# UNITED STATES PATENT AND TRADEMARK OFFICE

APPLICATION NO.	FILING DATE	FIRST NAMED INVENTOR	ATTORNEY DOCKET NO.	CONFIRMATION NO.
10/791,052	03/01/2004	Kuo Tsung-Jung	251209-1150	2867

<b>Office Action Summary</b>	<b>Application No.</b>	<b>Applicant(s)</b>	
	10/791,052	TSUNG-JUNG, KUO	
	<b>Examiner</b>	<b>Art Unit</b>	
	Matthew G. Kayrish	2627

## **DETAILED ACTION**

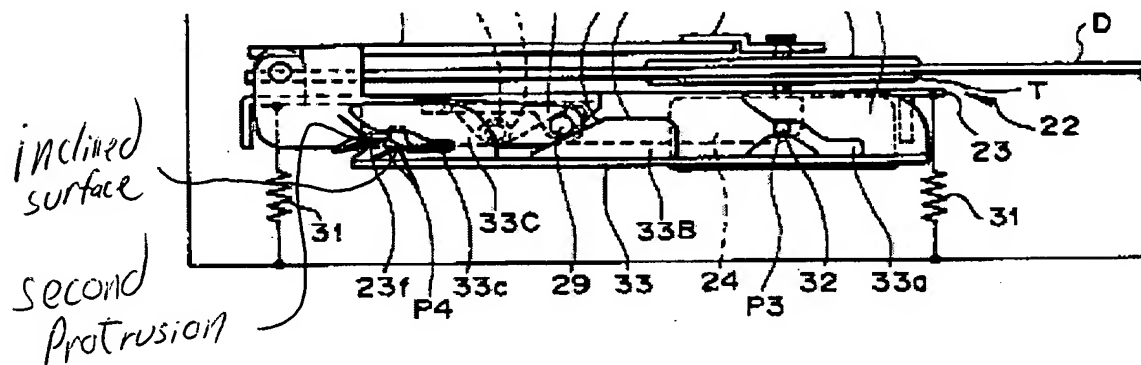
A clamper frame (figure 1, item 26) for holding a clamper (figure 1, item 27), pivoted (figure 1A, arrow a1-a2) on said substrate (figure 2, pivots about items 23 and 28) and having a first protrusion portion (figure 2, item 23f);

A sliding element (figure 1, item 33), movably mounted on said substrate (column 6, lines 37-41) and having an inclined portion, and a second protrusion (figure 1B below);

Wherein, after a disk is loaded into the optical disk device, said second protrusion portion abuts and pushes said first protrusion portion (figure 1B below).
